MEMORANDUM

Reference: Case No. PD-270-RBN, The Avenue at Denton Tap, a zoning change request from Commercial to a Planned Development to allow 29 multifamily units and 8,575 square feet of office/retail uses on 1.77 acres of property located at the northwest corner of Southwestern Boulevard and South Denton Tap Road.

STAFF REPORT

CASE NO. PD-270-RBN, The Avenue at Denton Tap

Site Plan

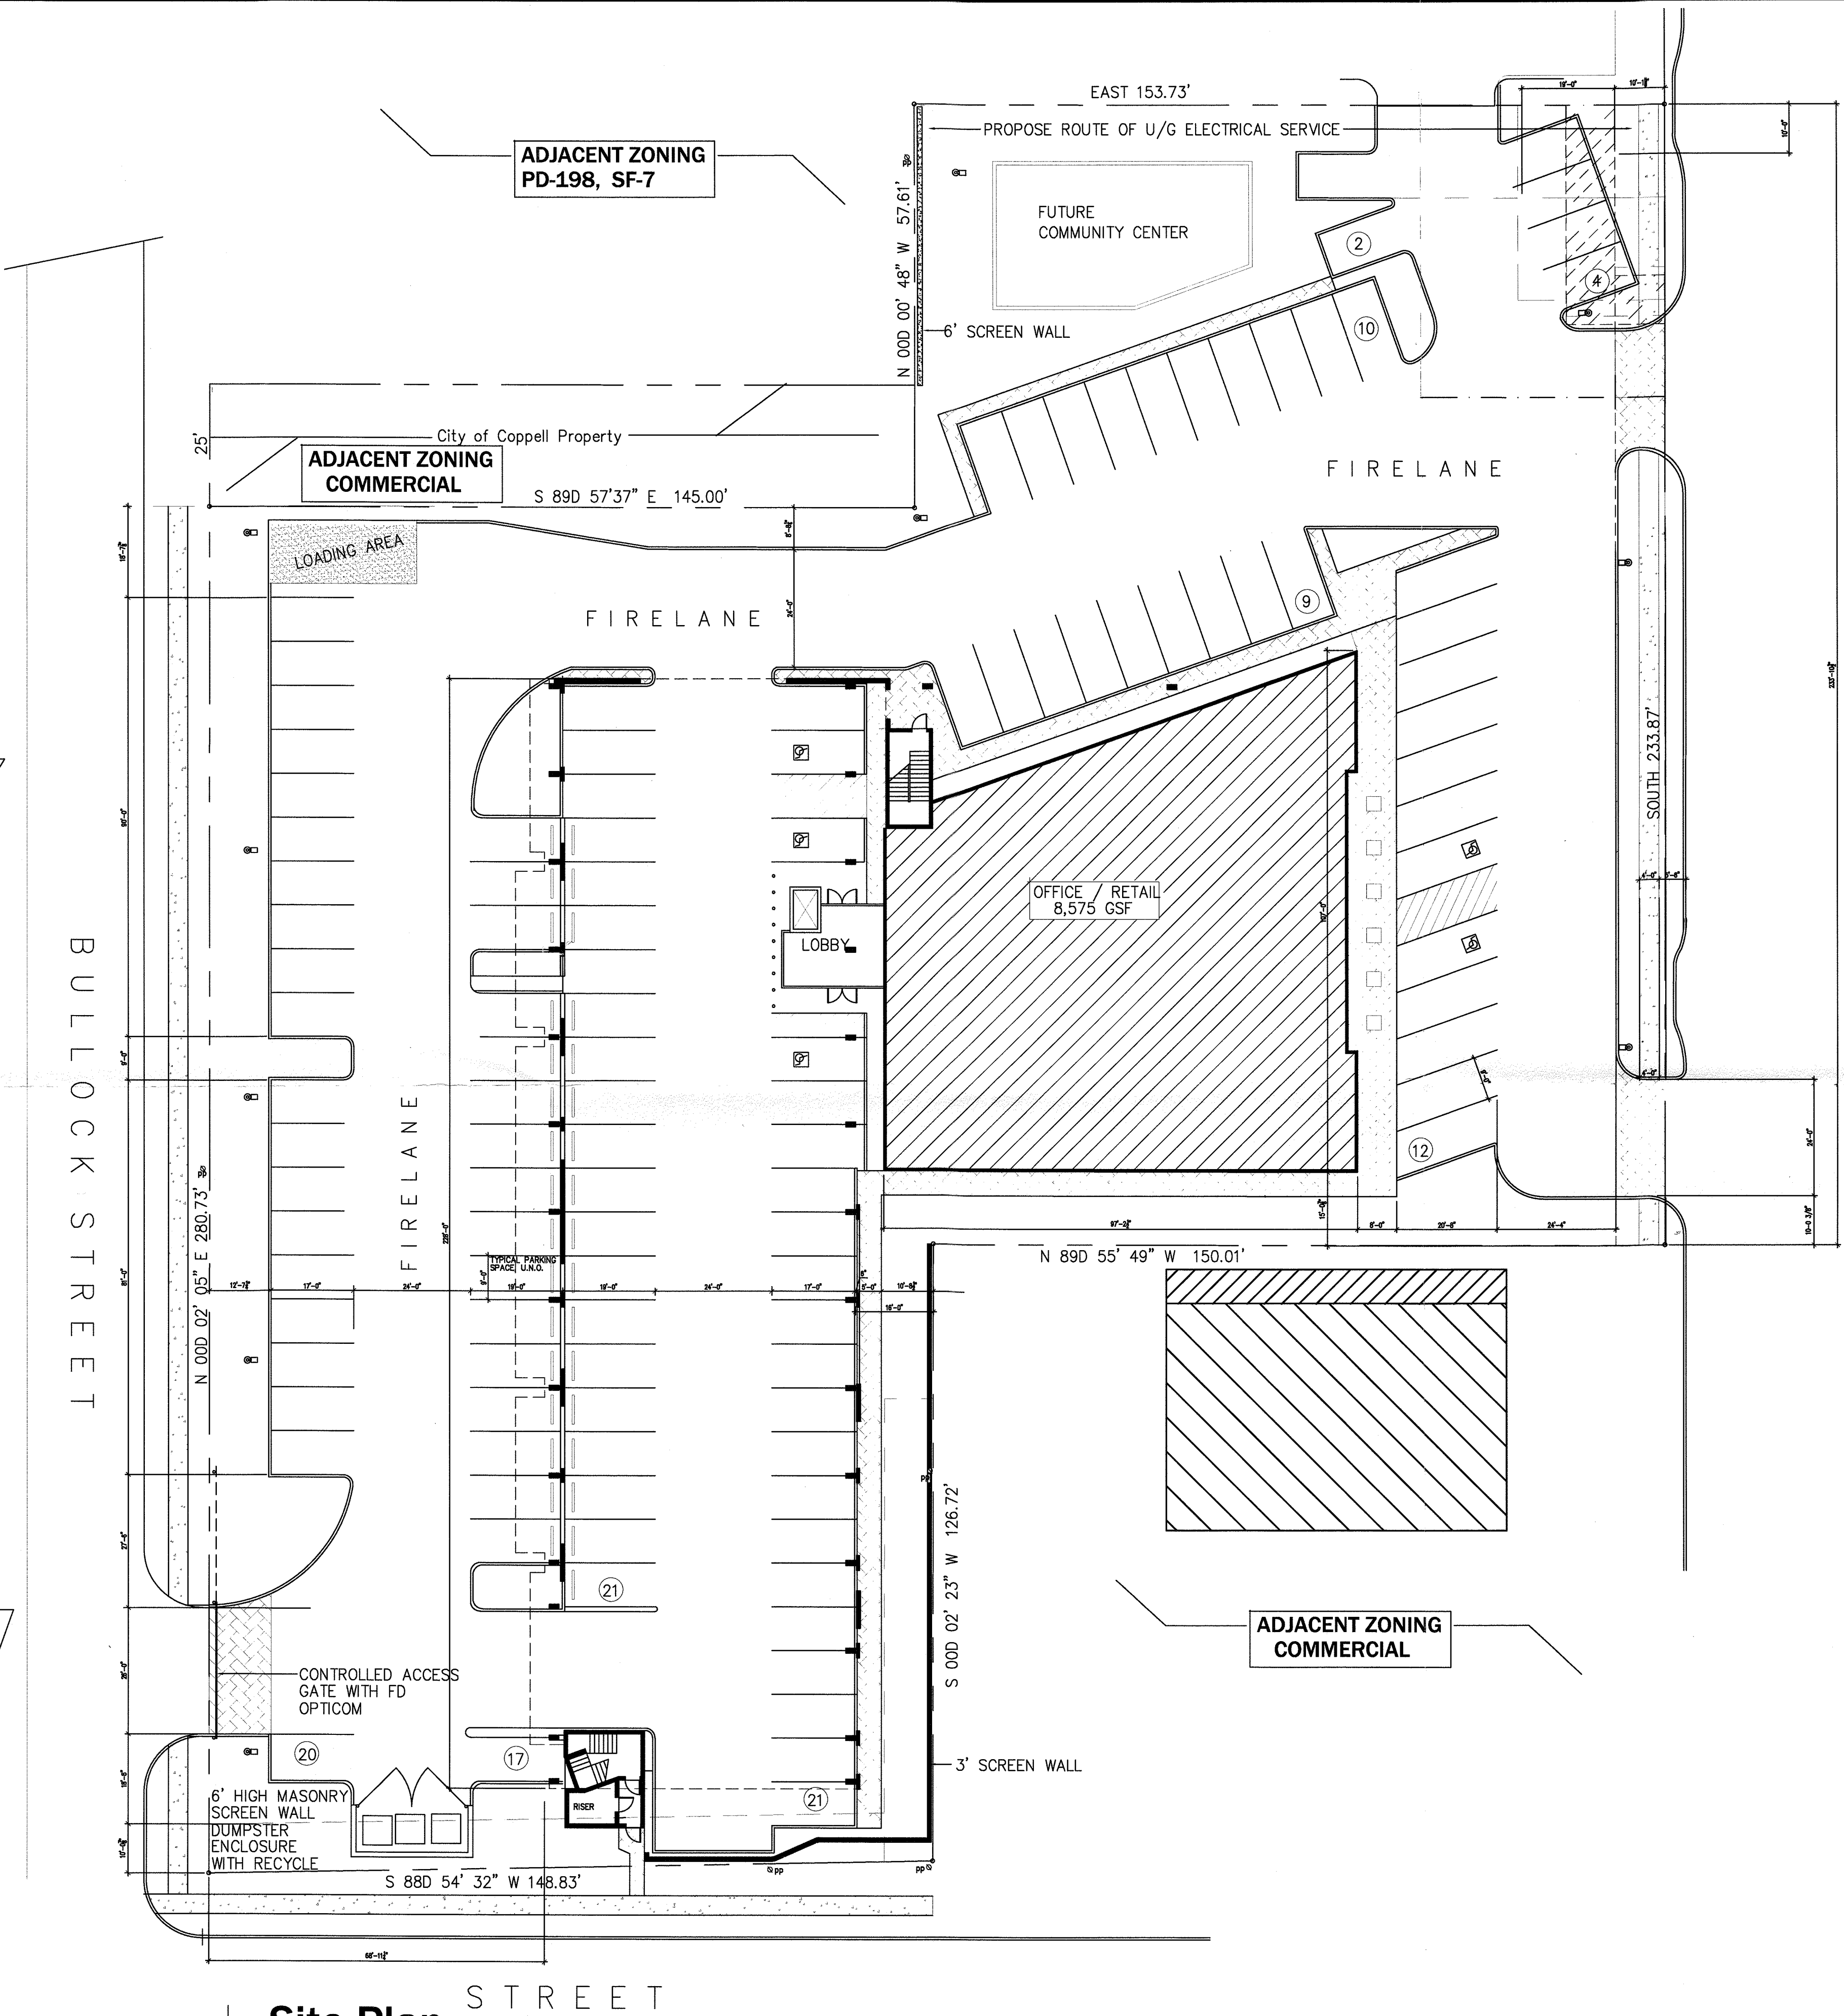
This building is proposed to be setback 63 feet from Denton Tap Road and 69 feet from Bullock Street. It is recommended that the 69-foot setback be supported to keep a buffer and transition from the residential neighborhood into the proposed higher intensity mixed use development.

A 36-foot setback is proposed along the northwest property line, which is adjacent to a 25-foot right-of-way providing a greater separation from the residential neighborhood. The main building is 63 feet from the Denton Tap Road right-of-way where the RBN District calls for a building to be no more than 15 feet from the lot line. Staff can support this deviation, as both a drive and parking are warranted for the office/retail use.

This proposal exceeds the 116 parking space requirement by providing 119 spaces. Both the *Comprehensive Plan* and the RBN District encourages structured (garage) parking. In this development 41 of the 119 spaces are contained within the structure. It is recommended that this parking area on the first floor be better screened with a three-foot masonry wall incorporated into each façade and this has

been listed as a condition of approval. Beyond the structured parking are 41 spaces in a parking lot. This area is proposed to be screened with a 12 foot wide landscaped area east of Bullock Street. The proposed off-street parking and drive (similar to a slip street recognized in the Comprehensive Plan). The proposed parking located on the Denton Tap Road side is angled with a one-way drive to provide an opportunity for streetscaping without actually having dangerous on-street parking on Denton Tap.

1. Additional Comments will be generated during detailed Engineering Plan Review.
2. Minor Plat approval is required prior to obtaining a building permit.
3. Park fees of \$1,285 per unit shall be paid prior to building permit.
4. Draft property owners association documents are required to be submitted for attorney review and filed at the time of plat recordation if units are sold individually.
5. Submit Future Community Center plans to the Director of Planning for administrative review, prior to permitting or construction.

1 LANDSCAPE PLAN
SCALE 1"=20'

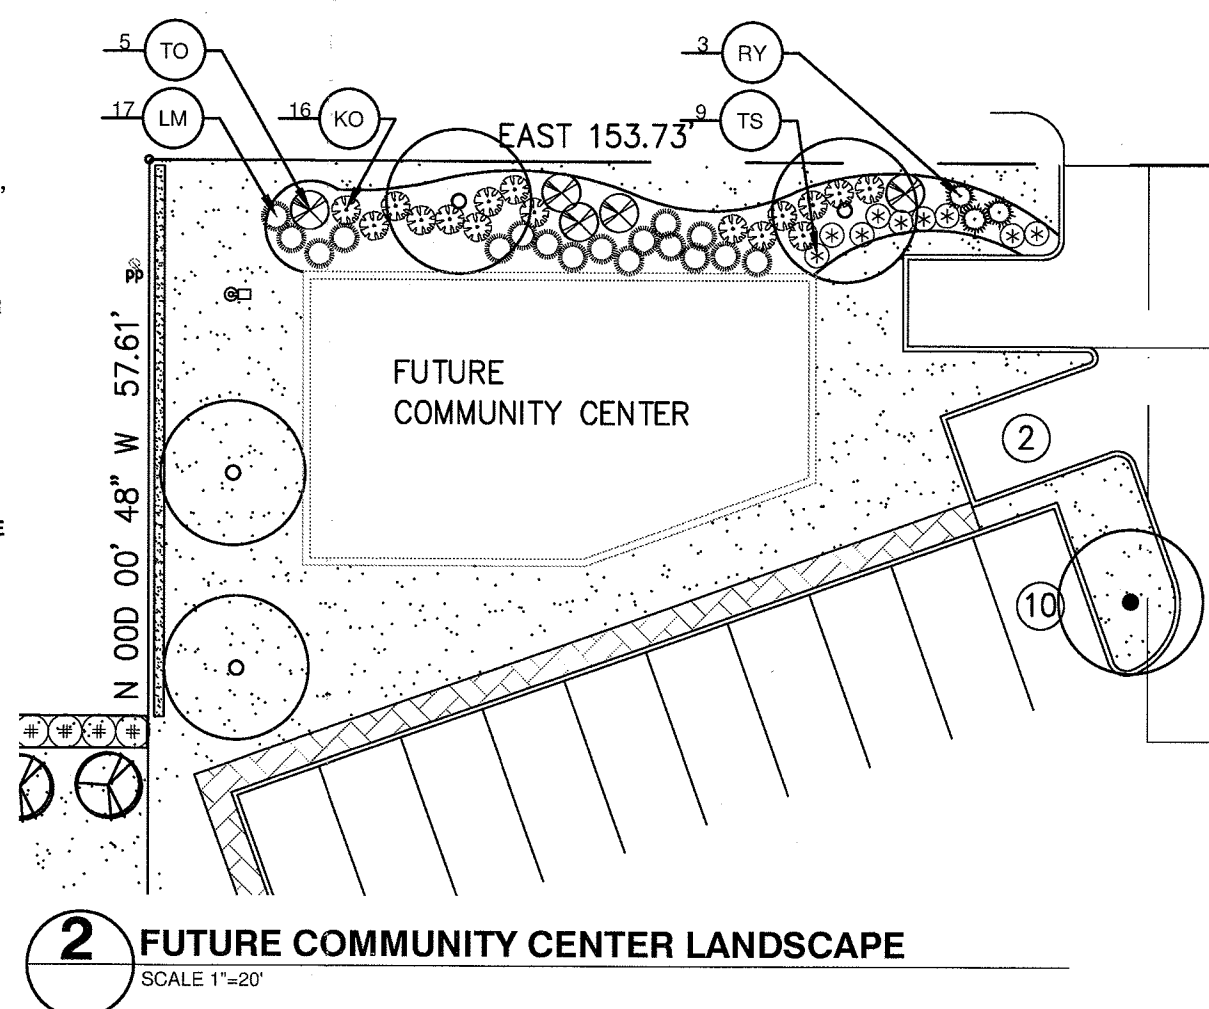
The landscape areas within a RBN District are different than the typical business zoning districts where under the RBN, a minimum 15% open space/common area is required. The proposal indicates that 17% has been provided. The streetscaping of the retail/office area is adequate where street trees are being provided. However, additional landscape islands are being recommended in the parking lot where there is no structure over the parking. Not more than 15 parking spaces are typically permitted without an island and one island is required at the end of each parking row; therefore, three islands are recommended. Also, the applicant has agreed to add an evergreen area of landscaping (containing Nellie R. Stevens and Eastern Red Cedars) to the 25 foot right-of-way strip located northwest of the property to better buffer/screen this proposal from the existing residential neighborhood.
